March 14, 2001
CEOG-01-065

Subject: Transmittal of Approved Topical Report CE NPSD-1168-A, Rev 00

CE NPSD-
1168-A, Rev 00

Joint Applications Report for Containment Isolation Valve AOT Extension

Figure 2: Schematic of Penetration Connected Directly to Containment Atmosphere and Outside Environment -- Penetration Path A1

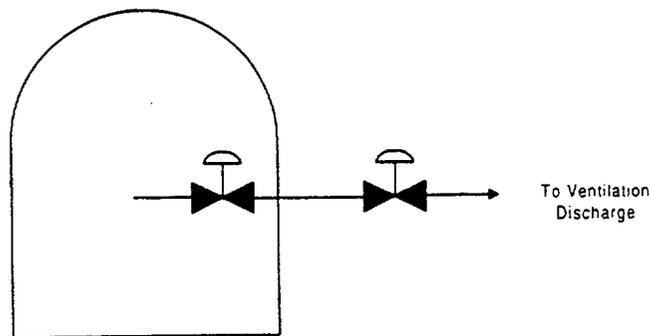
ID	Description of Penetration Flow Path	Calculation Method	Comment
A1	CIVs in penetrations connected directly to containment atmosphere and outside environment (See Figure 2)	<p>SINCE THE PIPING OUTSIDE CONTAINMENT IS OPEN, NO DIFFERENTIATION IS MADE BETWEEN SEISMIC AND NON-SEISMIC EVENTS</p> $SAOT_{L,RF} = \Delta CDF * P_{CIV} * \frac{AOT}{8760} = 8.8E-9$ <p>where</p> <p>$SAOT_{L,RF}$ = single AOT risk for large early release</p> <p>ΔCDF = change in CDF, baseline CDF assumed to be: $2E-4/yr$</p> <p>P_{CIV} = failure probability of unaffected CIV (solenoid type): $2.3E-3$</p> <p>$\frac{AOT}{8760}$ = fraction of full duration of AOT (i.e., 168 hours) to a year</p>	<p>Specific Assumptions:</p> <ul style="list-style-type: none"> Inoperability of one CIV is detected during periodic surveillance or cycling of the valve. The inoperable CIV is in the open position and the other CIV is the only barrier for releases to the environment. The failure mechanism causing the operable CIV to open also prevents it from closing if a demand occurs. <p>REVIEW COMMENTS:</p> <ul style="list-style-type: none"> The unaffected CIV is assumed to be OPERABLE. It is assumed that the cause of the failure of the affected CIV is not shared by the redundant CIV. That is, common cause failure is absent. The redundant valve is treated as same-as-new.

ID	Description of Penetration Flow Path	Failure Mode	CDF Impact	LERF Impact
A1	CIVs associated with these flow paths isolate the containment in the event of an accident. CIVs in penetrations connected directly to containment atmosphere and outside environment. (See Figure 2)	Inoperable or open CIV following an accident could result in a direct pathway to the environment (containment bypass).	Since there is no direct effect on core cooling, a failed CIV in this configuration would have no impact on CDF.	A failed CIV could create a containment bypass path and would contribute to an early large release of radioactive materials to the environs.
A2	CIVs associated with these flow paths isolate the containment in the event of an accident. CIVs in penetrations connected directly to containment atmosphere and closed loop system outside environment. (See Figure 3)	Inoperable or open CIV following an accident could result in a direct pathway to the environment (containment bypass) for failed non-seismically qualified piping in a closed-loop cooling system outside containment.	Same as A1 above.	Failure of non-seismically qualified piping outside containment with a failed or inoperable CIV would contribute to an early large release of radioactive materials to the environs.

Figure 3: Schematic of Penetration Connected Directly to Containment Atmosphere and a Closed Loop System -- Penetration Path A2

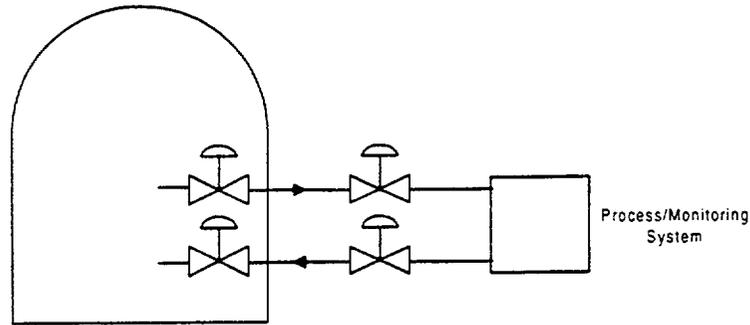
ID	Description of Penetration Flow Path	Calculation Method	Comment
A2	<p>CIVs in penetrations connected directly to containment atmosphere and closed loop system outside environment (See Figure 3)</p>	<p>NON-SEISMICALLY INITIATED EVENTS</p> $SAOT_{T,IR} = ACDF \cdot P_{CV} \cdot P_i \cdot \frac{AOT}{8760} = 1.5E-12$ <p>where</p> <p>$SAOT_{T,IR}$ = single AOT risk for large early release</p> <p>ACDF = change in CDF, baseline CDF assumed to be: 2E-4/yr</p> <p>P_{CV} = failure probability of unaffected CIV (air-operated): 3.85E-3</p> <p>P_i = probability of a pipe failure in closed loop system: 1E-4</p> <p>$\frac{AOT}{8760}$ = fraction of full duration of AOT (i.e., 168 hours) to a year</p> <p>SEISMICALLY INITIATED EVENTS</p> $SAOT_{T,IR} = ACDF \cdot P_{CV} \cdot \frac{AOT}{8760} = 1.3E-9$ <p>where</p> <p>ACDF = change in CDF, baseline CDF for seismic assumed to be: 1.75E-4/yr</p> <p>P_{CV} = same as above</p> <p>$\frac{AOT}{8760}$ = fraction of full duration of AOT (i.e., 168 hours) to a year</p>	<p>Specific Assumptions:</p> <ul style="list-style-type: none"> CIVs normally opened and cycled to satisfy in-service testing and TS requirements. Inoperability of one CIV is detected during periodic surveillance or cycling of the valve and it is secured in open position when found to be inoperable. CIVs may be either AOVs or solenoid-operated valves. The inoperable CIV remains open for all conditions and demands. Conditional failure probability is 1 following a seismic event for non-seismic piping systems. <p>REVIEW COMMENTS:</p> <ul style="list-style-type: none"> The unaffected CIV is assumed to be OPERABLE. Crediting close loop system as a barrier is applicable to cases in which the affected valve (the valve under CM) is intact. If not true, the value of $SAOT_{T,IR}$ of 1.5E-12 increases to 1.5E-8.

Figure 4: Schematic of Penetration Connected to Containment Atmosphere and an Open Loop System -- Penetration Path A3

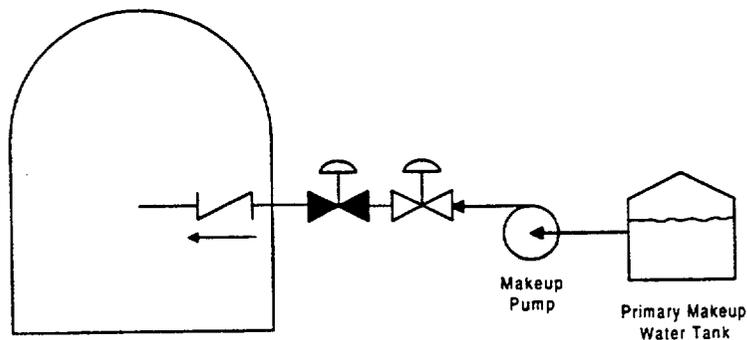
ID	Description of Penetration Flow Path	Calculation Method	Comment
A3	<p>CIVs in penetrations connected directly to containment atmosphere and open loop system outside environment (See Figure 4)</p>	<p>NON-SEISMICALLY INITIATED EVENTS</p> $SAOT_{LRR} = \Delta CDF \cdot P_{CK} \cdot P_n \frac{AOT}{8760} = 5.83E-13$ <p>where</p> <p>$SAOT_{LRR}$ = single AOT risk for large early release</p> <p>ΔCDF = change in CDF, baseline CDF assumed to be: 2E-4/yr</p> <p>P_{CK} = failure probability of unaffected CIV (check valve): 1.52E-3</p> <p>P_n = probability of a pipe failure in open loop system: 1E-4</p> <p>$\frac{AOT}{8760}$ = fraction of full duration of AOT (i.e., 168 hours) to a year</p> <p>SEISMICALLY INITIATED EVENTS</p> $SAOT_{LRR} = \Delta CDF \cdot P_{CK} \cdot \frac{AOT}{8760} = 5.1E-10$ <p>where</p> <p>ΔCDF = change in CDF, baseline CDF for seismic assumed to be: 1.75E-4/yr</p> <p>P_{CK} = same as above</p> <p>$\frac{AOT}{8760}$ = fraction of full duration of AOT (i.e., 168 hours) to a year</p>	<p>Specific Assumptions:</p> <ul style="list-style-type: none"> • CIVs are check valve inside containment and AOV outside containment. Failure of a check valve is 1.52E-3 per demand. • Inoperability of one CIV is detected during periodic surveillance or cycling of the valve and it is secured in open position when found to be inoperable. • For outside containment, there are multiple valves for isolation of a break and failure of multiple valves is assumed to be a low probability event and has no impact. • Pipe break cannot be isolated. • Piping outside the containment is non-seismically qualified and probability of pipe failure after a seismic event is 1.0. <p>REVIEW COMMENTS:</p> <ul style="list-style-type: none"> • The unaffected CIV is assumed to be OPERABLE. • In this case although the loop is open, the analysis effectively assumes a closed loop system by crediting other means of isolation as shown in term P_n. • As in the case of A2, crediting close loop system as a barrier is applicable to cases in which the affected valve (the valve under CM) is intact.

A3	CIVs associated with these flow paths isolate the containment in the event of an accident. CIVs in penetrations connected directly to containment atmosphere and open loop system outside environment. (See Figure 4)	A pipe break in an open-loop concurrent with a failure to isolate the containment penetration would establish a direct pathway to the environment (containment bypass).	Same as A1 above.	Failure of non-seismically qualified piping in the open-loop concurrent with an open CIV leads to containment bypass.
A4	CIVs associated with these flow paths isolate the containment in the event of an accident. CIVs in penetrations connected directly to closed loop system inside and outside containment. (See Figure 5)	A pipe break in a closed-loop system both inside and outside containment with failure to isolate the penetration would result in a direct pathway to the environment (containment bypass).	Same as A1 above.	Failure of non-seismically qualified piping in a closed-loop system both inside and outside containment concurrent with an open CIV leads to containment bypass.

Figure 5: Schematic of Penetration Connected to Closed Loop Inside and Outside Containment -- Penetration Path A4

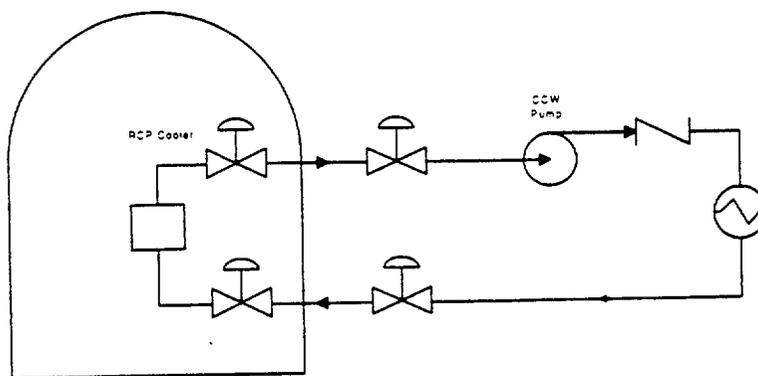
ID	Description of Penetration Flow Path	Calculation Method	Comment
A4	CIVs in penetrations connected directly to closed loop system inside and outside containment (See Figure 5)	<p>NON-SEISMICALLY INITIATED EVENTS</p> $SAOT_{LRR} = \Delta CDF \cdot P_{CIV} \cdot P_{IU} \cdot P_{IO} \cdot \frac{AOT}{8760} \ll 2E-13$ <p>where</p> <p>$SAOT_{LRR}$ = single AOT risk for large early release</p> <p>ΔCDF = change in CDF, baseline CDF assumed to be: $2E-4/yr$</p> <p>P_{CIV} = failure probability of unaffected CIV (air-operated): $3.85E-3$</p> <p>P_{IU} = probability of a pipe failure in close loop system inside containment: $1E-4$</p> <p>P_{IO} = probability of a pipe failure or inadvertent opening of a relief valve in closed loop outside containment: $6E-4$</p> <p>$\frac{AOT}{8760}$ = fraction of full duration of AOT (i.e., 168 hours) to a year</p> <p>FOR SEISMICALLY INITIATED EVENTS</p> $SAOT_{LRR} = \Delta CDF \cdot P_{CIV} \cdot \frac{AOT}{8760} = 1.3E-9$ <p>where</p> <p>ΔCDF = change in CDF, baseline CDF for seismic assumed to be: $1.75E-4/yr$</p> <p>P_{CIV} = same as above</p> <p>$\frac{AOT}{8760}$ = fraction of full duration of AOT (i.e., 168 hours) to a year</p>	<p>Specific Assumptions:</p> <ul style="list-style-type: none"> • Inoperability of one CIV is detected during periodic surveillance of the valve and it is secured in open position when found to be inoperable. • Piping (inside and outside) is non-seismically qualified and has a conditional failure probability of 1.0 for seismic events. • A breach in the piping of both inside and outside containment must fail concurrently with failure to isolate the penetration for a pathway to the environment. • Inadvertent opening of a relief valve will also breach the piping outside of containment and is given a probability of $5.0E-4$ for the proposed AOT. • AOV failure probability includes failure of the valve to close on demand or to remain closed during the proposed AOT. <p>REVIEW COMMENTS:</p> <ul style="list-style-type: none"> • The unaffected CIV is assumed to be OPERABLE. • Crediting close loop system outside containment as a barrier is applicable to cases in which the affected valve (the valve under CM) is intact. If not true, the value of $SAOT_{LRR}$ would increase by a factor of $1.0E4$.

Figure 6: Schematic of Penetration Connected to SI Line Leakage Path -- Penetration Path B1

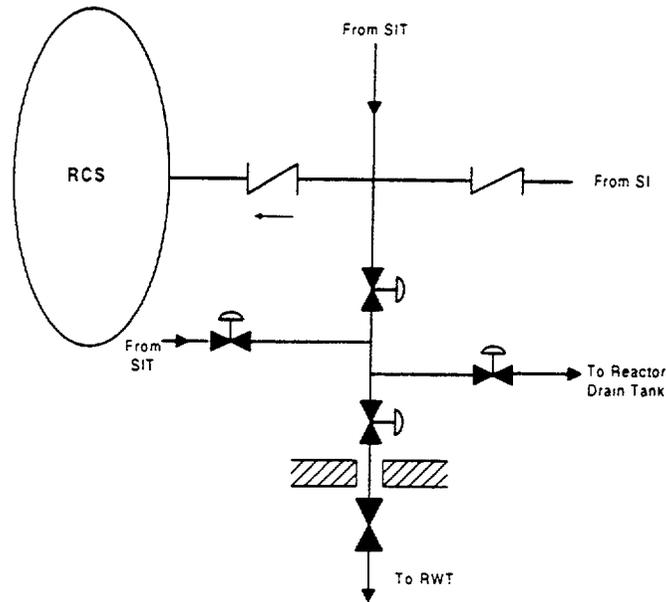
ID	Description of Penetration Flow Path	Calculation Method	Comment
B1	CIVs in penetrations connected to Safety Injection (SI) line check valve leakage path (See Figure 6)	$ISLOCA = \frac{\lambda_1 \lambda_2 \lambda_v T^2}{3} + \lambda_1 \lambda_2 \lambda_v \left[\frac{d_2 T + 1}{2} \right] + \lambda_1 \lambda_2 \lambda_v \left[\frac{d_3 T + 1}{2} \right]$ $+ 2 \lambda_1 \lambda_2 \lambda_v \left[\frac{d_2 T + 1}{2} \right] \left[\frac{d_3 T + 1}{2} \right] = 2.19E-8 \text{ per year}$ $SAOT_{LERR} = ISLOCA * \frac{AOT}{8760} = 4.19E-10$ <p>where,</p> <p>$SAOT_{LERR}$ = single AOT risk for large early release</p> <p>$ISLOCA$ = frequency of interfacing system LOCA per year: 2.19E-8 per year</p> <p>λ_1 = random leakage rate of SI check valve: 8.76E-4 per year</p> <p>λ_2 = random leakage rate of AOV: 7.0E-3 per year</p> <p>λ_v = random leakage rate of manually operated valve: 1.68E-3 per year</p> <p>λ_{v2} = probability of the AOV failing to reseal: 1.55E-3 per demand</p> <p>λ_{v1} = probability of the manually operated valve failing to reseal: 3.88E-4 per demand</p> <p>d_2 = the number of times the AOV is operated: 4</p> <p>d_3 = the number of times the manually operated valve is operated: 4</p> <p>T = fault exposure time: 1 year</p> <p>$\frac{AOT}{8760}$ = fraction of full duration of AOT (i.e., 168 hours) to a year</p>	<p>Specific Assumptions:</p> <ul style="list-style-type: none"> Assumed that penetration has one AOV on inside and one manually operated valve on outside the containment. The inoperability of the AOV is detected during surveillance or cycling of the valve. The failure mode of manually operated valves is not known but failure to reseal is bounded by a failure on demand of 3.88E-4 per demand. Average of four in-service tests of the manual CIV per year. Mean failure rate of an AOV transferring open is 7.98E-7 per hour and a bounding probability to fail on demand of 1.55E-3. The AOV is cycled once per quarter. Random leakage of a SI check valve is assumed to be 8.76E-4. Fault exposure time is equivalent to time that the plant operates in its non-cold shutdown modes, namely one year. A pressure transmitter can detect a leaking or stuck open SI check valve. <p>REVIEW COMMENTS:</p> <ul style="list-style-type: none"> The unaffected CIV is assumed to be OPERABLE. Without taking credit of the pressure transmitter, the result can change significantly. It appears that the expression used to estimate ISLOCA frequency is unnecessary complex. Verification of the correctness of the equation was not performed. It is recommended that the applicant fully derive the equation presented and provide additional discussion. The expression used in the JAR does not account for common cause failure of redundant valves.

B1	CIVs associated with these flow paths isolate the containment in order to minimize the leakage of reactor coolant. CIVs in penetrations connected to safety injection (SI) line check valve leakage path. (See Figure 6)	Failure of multiple barriers would result in over-pressurization of low pressure piping outside containment. Over-pressurization could lead to an interfacing system LOCA. A failed CIV inside containment reduces the number of barriers to protect the low pressure system.	The loss of reactor coolant to the low pressure piping outside containment impacts the effectiveness of ECCS.	Failure of the low pressure piping outside containment creates a direct leakage path for radioactive materials to the environs (containment bypass).
B2	CIVs associated with these flow paths isolate the containment in order to minimize the leakage of reactor coolant. CIVs in penetrations connected to the reactor coolant system (RCS) sample line. (See Figure 7)	CIV failure mode could lead to discharge of reactor coolant given a failure of non-seismically qualified piping outside containment.	Small impact expected for this event due to line size and ECCS make-up capability.	An inoperable and open CIV in conjunction with non-seismic piping failure would lead to a direct leakage path for radioactive materials to the environs.

Figure 7: Schematic of Penetration Connected to RCS Sample Line -- Penetration Path B2

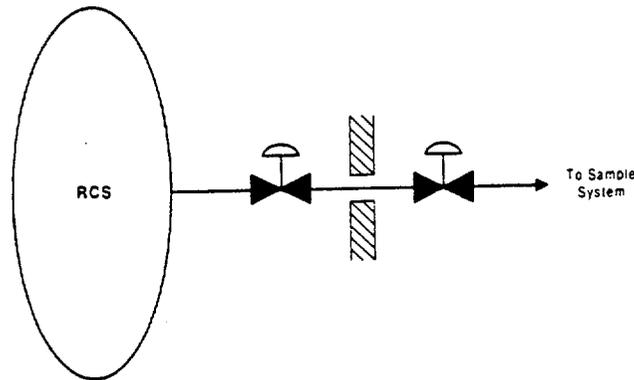
ID	Description of Penetration Flow Path	Calculation Method	Comment
B2	CIVs in penetrations connected to the reactor coolant system (RCS) sample line (See Figure 7)	$SAOT_{LRR} = CCDP_{SL} * F_P * P_{IRC} * \frac{AOT}{8760} = 8.23E-10$ <p>where,</p> <p>$SAOT_{LRR}$ = single AOT risk for large early release</p> <p>$CCDP_{SL}$ = total conditional core damage probability given the interaction of a small LOCA: 3.73E-3</p> <p>F_P = frequency of a random pipe failure occurring in the sample system creates a small LOCA: 5.0E-3 per year</p> <p>P_{IRC} = probability of the operable CIV failing to remain closed during the proposed AOT: 2.3E-3</p> <p>$\frac{AOT}{8760}$ = fraction of full duration of AOT (i.e., 168 hours) to a year</p> <p>FOR SEISMIC EVENTS:</p> <p>$SAOT_{LRR} = 6.57E-10$</p>	<p>Specific Assumptions:</p> <ul style="list-style-type: none"> • Both CIVs are AOVs. • CIVs assumed to be cycled daily and initially closed. Probability to remain closed is more conservative than failing to close on demand. • The same failure mechanism causing the CIV to transfer open prevents it from closing on demand. • Pipe failure due to exposure to high RCS temperature and pressure is negligible. • A break in the sample system can be compensated by charging system or ECCS and the plant can be shutdown in a timely manner so it will not lead to core damage. • Note: $CCDP_{SL} * F_P$ is equivalent to core damage frequency associated with a sample system pipe failure (1.9E-5). • Assumed exposure time used for P_{IRC} is equal to AOT. This assumption is not conservative. The exposure time should be the time between the last test to the end of AOT. <p>REVIEW COMMENTS:</p> <ul style="list-style-type: none"> • The unaffected CIV is assumed to be OPERABLE. • It is assumed that the cause of the failure of the affected CIV is not shared by the redundant CIV. That is, common cause failure is absent. • The redundant valve is treated as same-as-new.

Figure 8: Schematic of Penetration Connected to Letdown Line -- Penetration Path B3

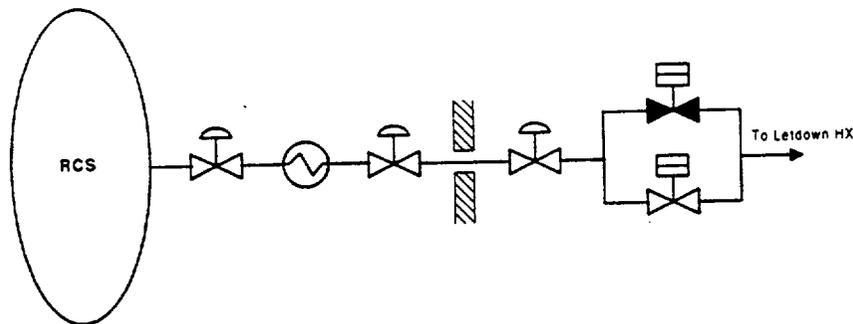
ID	Description of Penetration Flow Path	Calculation Method	Comment
B3	CIVs in penetrations connected to Letdown or reactor coolant pump (RCP) bleed-off line (See Figure 8)	<p>BREAK INSIDE CONTAINMENT:</p> $SAOT_{LRF} = ICCDP * P_{FIC}$ $= \left[CCDDP_M * F_p * P_{FIC} * \frac{AOT}{8760} \right] * P_{FIC}$ $= (5.54E-10) * (1.55E-3) = 8.59E-13$ <p>BREAK OUTSIDE CONTAINMENT:</p> $SAOT_{LRF} = ICCDP = F_p * P_N * \frac{AOT}{8760}$ $= 7.82E-9$ <p>where</p> <p>$SAOT_{LRF}$ = single AOT risk for large early release</p> <p>$ICCDP$ = incremental conditional core damage probability</p> <p>$CCDDP_M$ = total conditional core damage probability given the interaction of a small LOCA: 3.73E-3</p> <p>F_p = frequency of a random pipe failure occurring in the letdown line inside or outside containment: 5.0E-3/yr for inside and 2.63E-3/yr for outside</p> <p>P_{FIC} = probability of the remaining CIVs failing to closed by common cause during the proposed AOT: 1.55E-3</p> <p>P_N = probability of both CIVs failing to closed during the proposed AOT: 1.55E-4</p> <p>$\frac{AOT}{8760}$ = fraction of full duration of AOT (i.e., 168 hours) to a year</p>	<p>Specific Assumption:</p> <ul style="list-style-type: none"> All valves are AOVs and AOV failure to close is 1.55E-3. Failure of the actuation signal to close the AOV is negligible when compared with hardware failures. Inoperability of one CIV can be detected and secured in open position. The two other AOVs can isolate the containment. Break is assumed between the two CIVs inside containment and the one downstream of the regenerative heat exchanger is inoperable and in the open position. Breach in outside line is downstream of the outside CIV from piping failure or failure of a relief valve (probability of 2.13E-2 per year). The probability of both operable CIVs failing to close is dominated by common cause failure for a probability of 1.55E-4. <p>REVIEW COMMENTS:</p> <ul style="list-style-type: none"> In the text, the equation for a break outside containment has CLERP not ICLERP. This is assumed to be a typo. The unaffected CIV is assumed to be OPERABLE. For this situation, the licensee may be able to enter the LCO by removing two CIVs. It is recommended that guidance be provided that only one CIV of a pair could be removed at a time.

ID	Description of Penetration Flow Path	Failure Mode	CDF Impact	LERF Impact
B3	<p>CIVs associated with these flow paths isolate the containment in order to minimize the leakage of reactor coolant.</p> <p>CIVs in penetrations connected to letdown or reactor coolant pump (RCP) bleed-off line. (See Figure 8)</p>	<p>Piping failure inside containment between CIVs or outside containment downstream of the CIV with an inoperable CIV leads to a non-isolatable containment penetration.</p>	<p>A break inside containment between the two CIVs is considered to be a small break LOCA. A break outside containment is similar in consequence. However, loss of coolant inventory would not be available for long-term make-up and heat removal and impact CDF.</p>	<p>Either failure mode with an open CIV in conjunction with a postulated piping break leads to a direct release path for radioactive materials to the environs (containment bypass).</p>

Figure 9: Schematic of Penetration Connected to Non-Essential Cooling Units -- Penetration Path C1

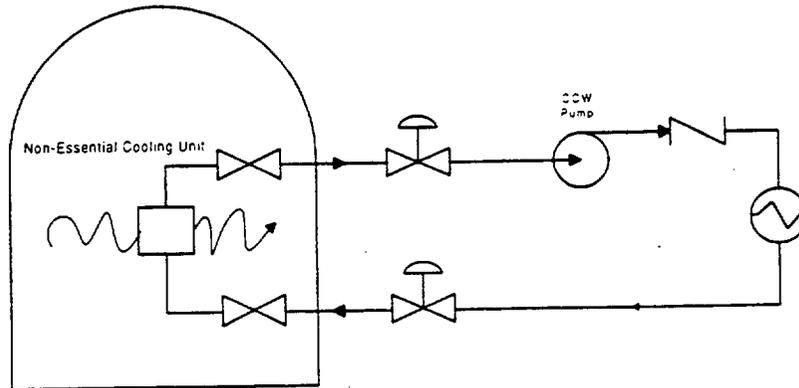
ID	Description of Penetration Flow Path	Calculation Method	Comment
C1	CIVs in penetrations connected to non-essential containment cooling (See Figure 9)	<p>CASE INVOLVING A RANDOM PIPE FAILURE AND CAUSING REACTOR SCRAM:</p> $SAOT_{CDF} = ICCDP = CCDP_1 * F_p * \frac{AOT}{8760}$ $= 3.07E - 9$ $SAOT_{LIRI} = ICCDP * P_R$ $= 1.84E - 12 \text{ (without } P_f \text{)}$ <p>CASE INVOLVING A PIPE FAILURE CONCURRENT WITH CORE DAMAGE:</p> $SAOT_{LIRI} = ACDP * P_f * P_R * \frac{AOT}{8760}$ $= 2.30E - 13$ <p>where</p> <p>$SAOT_{CDR}$ = single AOT risk for core damage</p> <p>$SAOT_{LIRI}$ = single AOT risk for large early release</p> <p>$CCDP_1$ = conditional core damage probability due to reactor trip: 6.08E-6</p> <p>$ICCDP$ = incremental conditional core damage probability</p> <p>$ACDP$ = change in CDF, baseline CDF assumed to be: 2E-4/yr</p> <p>F_p = frequency of breaching a closed loop system outside the containment: 2.63E-2 per year</p> <p>P_f = probability of a pipe failure in the closed loop system inside the containment: 1.0E-4</p> <p>P_R = probability of a pipe failure in the closed loop system outside the containment: 6.0E-4</p> <p>$\frac{AOT}{8760}$ = fraction of full duration of AOT (i.e., 168 hours) to a year</p>	<p>Specific Assumptions:</p> <ul style="list-style-type: none"> • One AOV per penetration and is open during normal operation. • Inadvertent opening of a relief valve will also breach the piping outside of containment and is given a probability of 5.0E-4 for the proposed AOT. The combination of relief and piping failure yield a probability of 6.0E-4. • A breach in the piping of both inside and outside containment must fail for a pathway to the environment. <p>REVIEW COMMENTS:</p> <ul style="list-style-type: none"> • The equation for the case involving a pipe failure and causing reactor scram may need to have a probability for pipe failure outside containment to complete the pathway to the environment (P_f). • The unaffected CIV is assumed to be OPERABLE. • A breach in the closed loop system during power operation is assumed to cause an uncomplicated reactor trip. • The presented analysis is valid if the breach does not impact the CCW function.

C1	<p>CIVs associated with these flow paths isolate the containment in the event of an accident.</p> <p>CIVs in penetrations connected to non-essential containment cooling. (See Figure 9)</p>	<p>An open CIV leads to a direct pathway from the containment to the environs in the event of a break in a closed-loop system inside and outside the containment.</p>	<p>Little impact would be expected for an open CIV and a failed closed cooling system. An inadvertent opening of a relief valve or break in a closed loop system during power operation would result in a reactor trip with a small impact on CDF.</p>	<p>In this event, the inability to provide containment isolation would lead to a direct release pathway for radioactive materials to the environs (containment bypass).</p>
C2	<p>CIVs associated with these flow paths isolate the containment in the event of an accident.</p> <p>CIVs in penetrations connected to secondary side of steam generator. (See Figure 10)</p>	<p>Failed CIV to isolate a steam generator with a ruptured steam generator tube allows a release of reactor coolant outside containment through failed non-seismically qualified piping or an open safety-relief valve.</p>	<p>An open CIV in this case has the potential to impact CDF due to loss of coolant outside containment.</p>	<p>Direct pathway to environs would be created in the event of a CIV in the open position and a SG tube rupture event.</p>

Figure 10: Schematic of Penetration Connected to Steam Generator -- Penetration Path C2

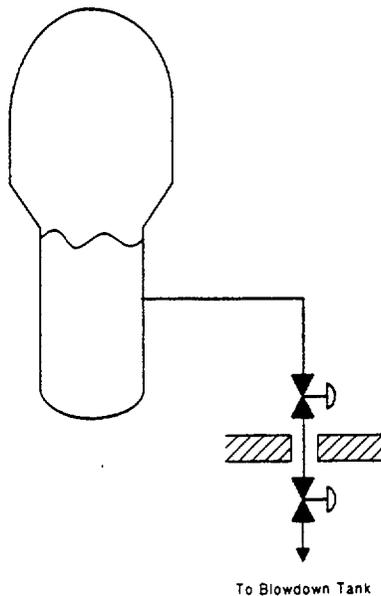
ID	Description of Penetration Flow Path	Calculation Method	Comment
C2	CIVs in penetrations connected to secondary side of steam generator (See Figure 10)	$SAOT_{LIR} = CCDP_{SGTR} * P_{TRC} * F_R * \frac{AOT}{8760}$ $= 2.02E-10$ <p>where</p> $SAOT_{LIR} = \text{single AOT risk for large early release}$ $CCDP_{SGTR} = \text{conditional core damage probability due to SGTR: } 9.16E-4$ $P_{TRC} = \text{probability of the operable CIV failing to remain closed during the proposed AOT: } 2.3E-3$ $F_R = \text{random pipe failure of blowdown piping outside the containment: } 5.0E-3 \text{ per year}$ $\frac{AOT}{8760} = \text{fraction of full duration of AOT (i.e., 168 hours) to a year}$	<p>Specific Assumptions:</p> <ul style="list-style-type: none"> • A penetration has two closed AOVs and once one is determined inoperable, it is secured open. • For a path to the environment, a SGTR event must also occur concurrently with a transfer opening of the closed CIV. • The piping outside of the containment is non-seismically qualified. <p>REVIEW COMMENTS:</p> <ul style="list-style-type: none"> • The unaffected CIV is assumed to be OPERABLE. • It is assumed that the cause of the failure of the affected CIV is not shared by the redundant CIV. That is, common cause failure is absent. • The redundant valve is treated as same-as-new.

Figure 11: Schematic of Penetration Connected to Containment Instrument Sensor -- Penetration Path D

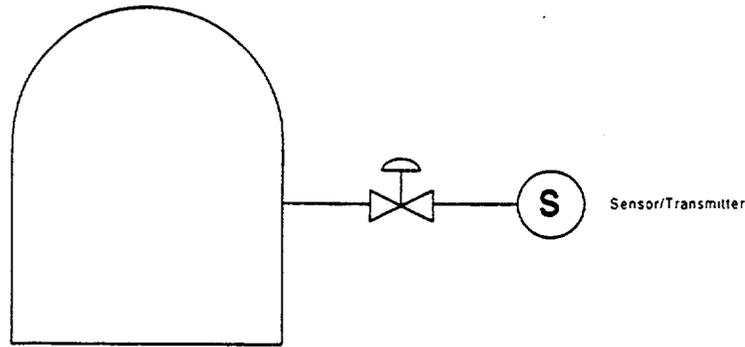
ID	Description of Penetration Flow Path	Calculation Method	Comment
D	CIVs in penetrations connected to containment atmosphere pressure detector (See Figure 11)	No equations, qualitative assessment	Proposed by CEOG to be negligible and well below acceptance criteria of 5.0E-7 and 5.0E-8 for ICCDP and ICERLP respectively.
E1	CIVs in penetrations used to support RCS inventory control safety function under accident condition (See Figure 12)	<p>HPS/ILPSI LINE:</p> $ISLOCA = \frac{\lambda^2 T}{2} + \lambda \lambda_d \left[\frac{dT + 1}{2} \right]$ $SOAT_{LIRI} = ISLP = ISLOCA * P_c * \frac{AOT}{8760}$ $= 1.68E-9$ <p>where</p> <p>$SAOT_{LIRI}$ = single AOT risk for large early release</p> <p>ISLP = incremental conditional ISLOCA probability</p> <p>ISLOCA = frequency of interfacing system LOCA per year: 8.76E-7</p> <p>λ = random leakage rate of SI check valve: 8.76E-4 per year</p> <p>λ_d = probability of the second check valve failing to reset: 2.81E-4 per demand</p> <p>d = the number of times the check valve is operated: 3</p> <p>P_c = conditional probability of pipe failure following exposure to RCS pressure: 0.1</p> <p>T = fault exposure time: 1 year</p> <p>$\frac{AOT}{8760}$ = fraction of full duration of AOT (i.e., 168 hours¹) to a year</p>	<p>Specific Assumptions:</p> <ul style="list-style-type: none"> Assumed that penetration has two check valves on inside and one MOV on outside the containment. The inoperability of the MOV is detected during surveillance or cycling of the valve. Piping upstream of the MOV can fail if exposed to RCS pressure with a conditional probability of 0.1. A pressure transmitter can detect a leaking or stuck open SI check valve. Random leakage of a SI check valve is assumed to be 8.76E-4. Average of three cold-shutdowns per year where the SI check valves are operated. Fault exposure time is equivalent to time that the plant operates in its non-cold shutdown modes, namely one year. <p>REVIEW COMMENTS:</p> <ul style="list-style-type: none"> Without taking credit of the pressure transmitter, the result can change significantly. It appears that the expression used to estimate ISLOCA frequency is unnecessary complex. Verification of the correctness of the equation was not performed. It is recommended that the applicant fully derive the equation presented and provide additional discussion. In this case although the loop is open, the analysis effectively assumes a closed loop system by crediting other means of isolation as shown in term P_c. Crediting close loop system as a barrier is applicable to cases in which the affected valve (the valve under CM) is intact.

D	<p>CIVs in these flow paths are designed to open during power operation and provide input to ESFS; designed to open during post accident conditions.</p> <p>CIVs in penetrations connected to containment atmosphere pressure detector. (See Figure 11)</p>	<p>CIV failure in the open position in a containment sensor line would create a direct path to the environs (containment bypass) should the sensor also fail.</p>	<p>No impact on CDF would result with a failed or open CIV.</p>	<p>An accident occurring with a failed or open CIV would not of itself create bypass leakage path to the environs. However, in conjunction with a concurrent failed sensor, a direct leakage path to the environs (containment bypass) would be created.</p>
E1	<p>CIVs in these flow paths have varied functions: (1) safety injection, (2) make-up to RCS, and (3) support post accident heat removal. The penetrations are designed to be open in the event of an accident and some may be opened during normal plant operations.</p> <p>CIVs in penetrations used to support RCS inventory control safety function under accident conditions. (See Figure 12)</p>	<p>Concern over failure of low pressure portion of HPS/LPSI piping upstream of header CIVs (charging line is not of consequence here because it is designed to full system pressure).</p> <p>HPS/LPSI with CIV secured in either the closed or open position.</p>	<p>CIV in closed position results in CDF impact due to loss of system operability. On the other hand, CIV in secured open position would allow system operability but with reduced number of barriers present.</p>	<p>No pathway bypassing containment would occur for the secured closed CIV. On the other hand, a secured open CIV with failure of low pressure piping would result in a bypass pathway for release of radioactive materials.</p>
